**MEMORANDUM**

DATE: December 3, 2004
 TO: Montgomery County Planning Board
 Rose Krasnow, Chief *REK*
 VIA: Michael Ma, Supervisor *MA*
 Development Review Division
 FROM: Robert A. Kronenberg, RLA *RAK*
 Development Review Division
 (301) 495-2187

REVIEW TYPE: **Site Plan Review**
 CASE #: **8-05011**
 PROJECT NAME: **Twinbrook Commons**
 APPLYING FOR: Approval of 440 multi-family dwelling units, including 55 MPDUs and 60,099 square feet of commercial retail
 REVIEW BASIS: Div. 59-D-3 of Montgomery County Zoning Ordinance

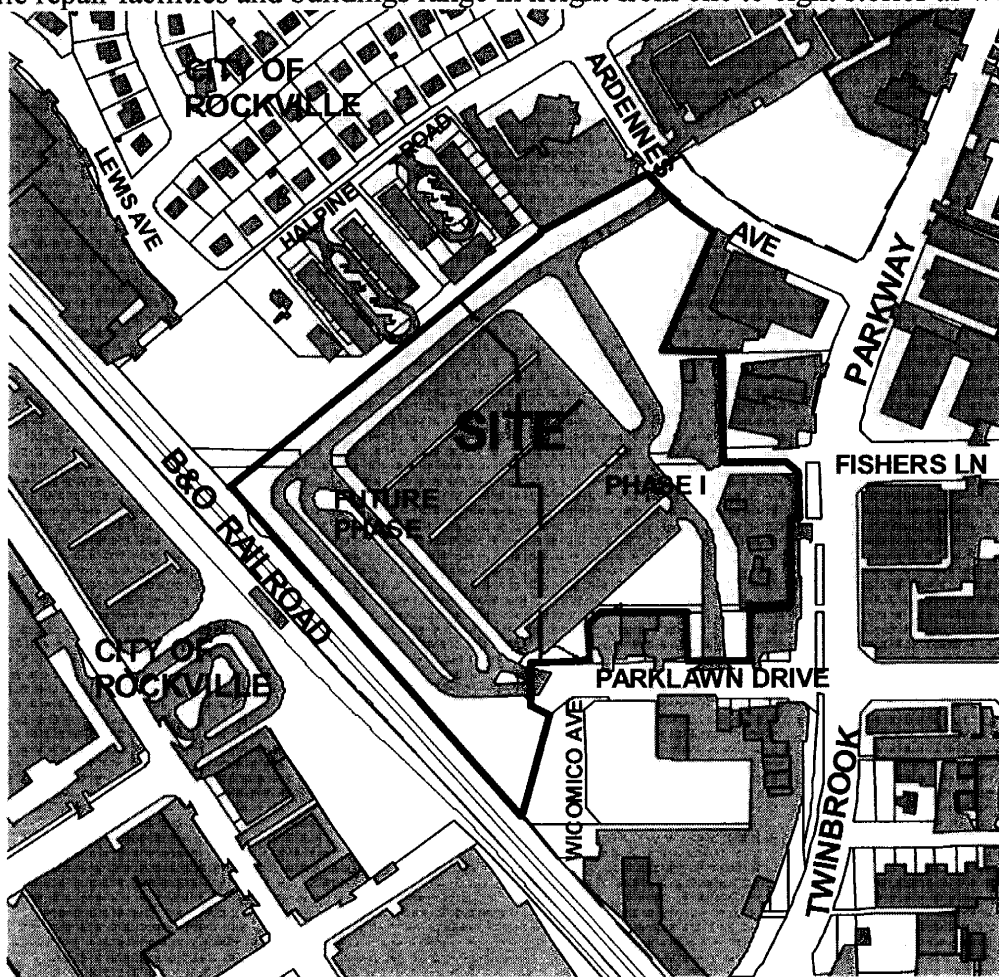
The Phase I portion of the site includes development adjacent to the Cambridge Walk townhouse community and Halpine Church with a primary access to this area from Halpine Road via Ardennes Avenue. Concerns were raised with regard to buffers from the proposed development to the existing community and compatibility of uses at their property boundary. The development adjacent to the existing community is proposed to be 4-stories and the linear park area is forty feet in width. The existing townhouses are 3-story brick structures.

The adjacent townhouse community of Cambridge Walk and the Halpine Church voiced specific concerns during the rezoning as well as the during the Phase I site plan over issues pertaining to building height, appropriate buffers to their properties and lighting. The adjacent community has expressed their support for buildings no taller than 4 stories in height adjacent to their property line, a forty-foot linear park providing a necessary buffer of existing and proposed plant material and lighting that does not project into their property from the proposed development.

Staff supports the requests made by the community for building heights and buffers to the proposed development. The Phase I site plan and conditions provide for all of the information and detail requested by the community. Staff has reviewed the application to ensure that all of the requests made by the community have been met. A Tree Protection Plan is also part of the approval of the Phase I site plan to address impacts to the existing trees from the proposed development to ensure all possible means of survivability.
